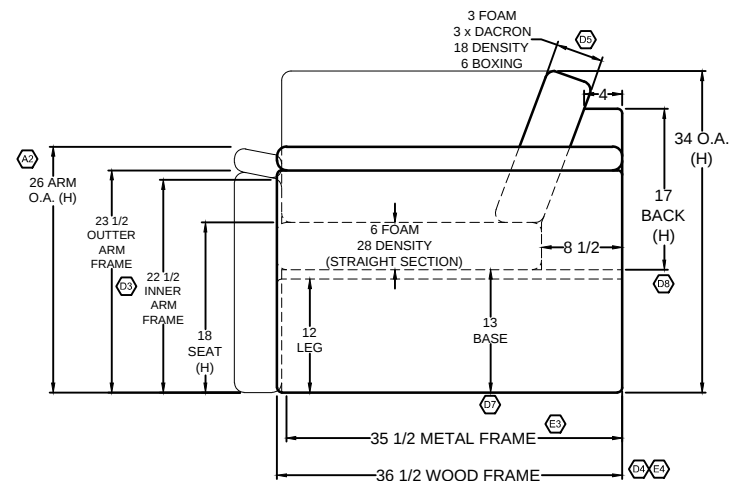
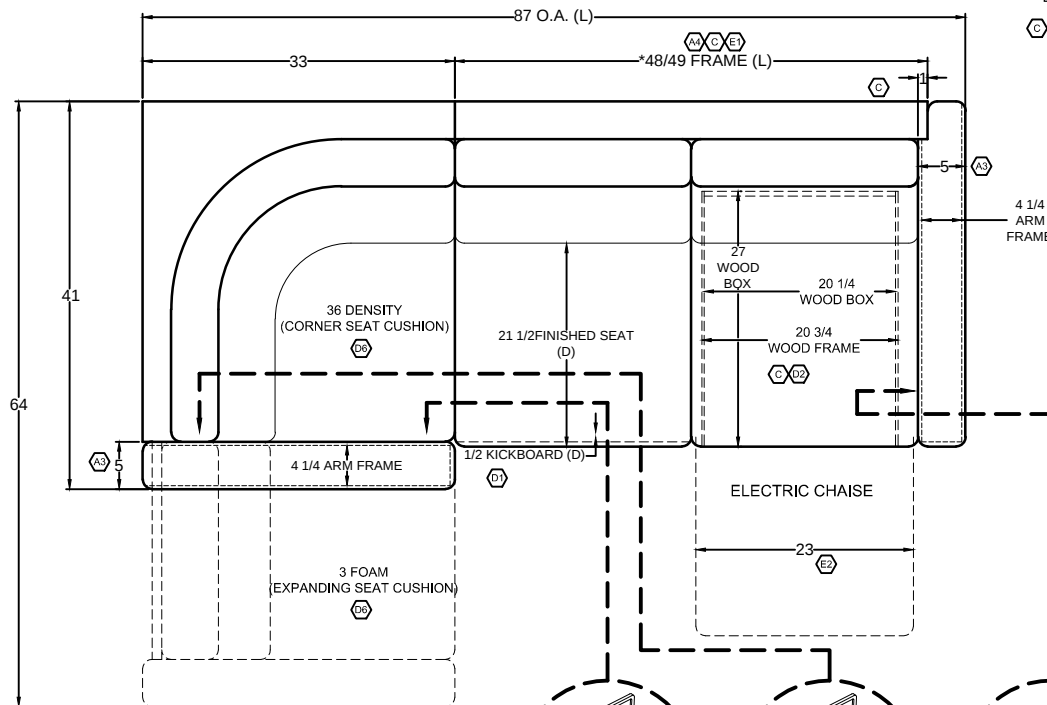
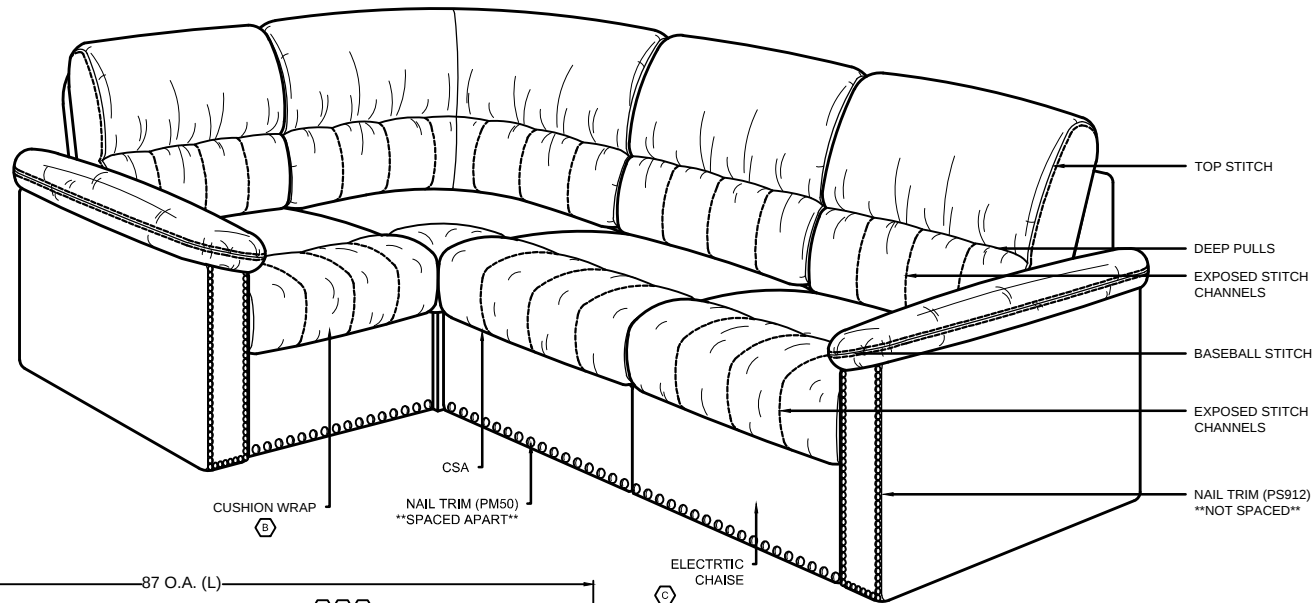
LB	E	PRODUCTION UPDATE: [1] CHANGED LENGTH OF FRAME TO 48/49"; WAS 50"; [2] ADDED ELECTRIC CHAISE WIDTH DIMENSION, [3] ADDED METAL FRAME DEPTH DIMENSION, [4] ADDED WOOD FRAME DEPTH DIMENSION.	05.29.19
JA	D	PRODUCTION UPDATE: [1] CHANGE R6 DEPTH TO 12"; WAS 2-1/2"; [2] UPDATED CHAISE WOOD DIMENSIONS, [3] ADDED ARM FRAME DIMENSIONS, [4] CHANGED RAF DEPTH TO 36-1/2"; WAS 35-1/2"; [5] UPDATED BACK PILLOW DETAILS, [6] ADDED SEAT FOAM DETAILS, [7] ADDED 13" BASE HEIGHT DIM, [8] CHANGED BACK FROM HEIGHT TO 17"; WAS 18".	02.07.19
JA	C	PER RL, ADDED ELECTRIC CHAISE TO RAF SIDE. (ADJUSTED FRAME WIDTH TO 49"). AND ADJUSTED DRAWING TO HAVE THE SAME SPECS AS PART # VI4000562.	12.17.18
JA	B	PER RL, RE-ADDED CUSHION WRAP DESCRIPTION TO DRAWING.	08.24.18
AC	A	[A1] REMOVED CUSHION WRAP ON SEATS. [A2] INCREASED FINISHED ARM HEIGHT TO 26"; WAS 25". [A3] INCREASED FINISHED ARM WIDTH TO 6"; WAS 5". [A4] REDUCED FRAME SIZE TO 48"; WAS 49".	10.12.17
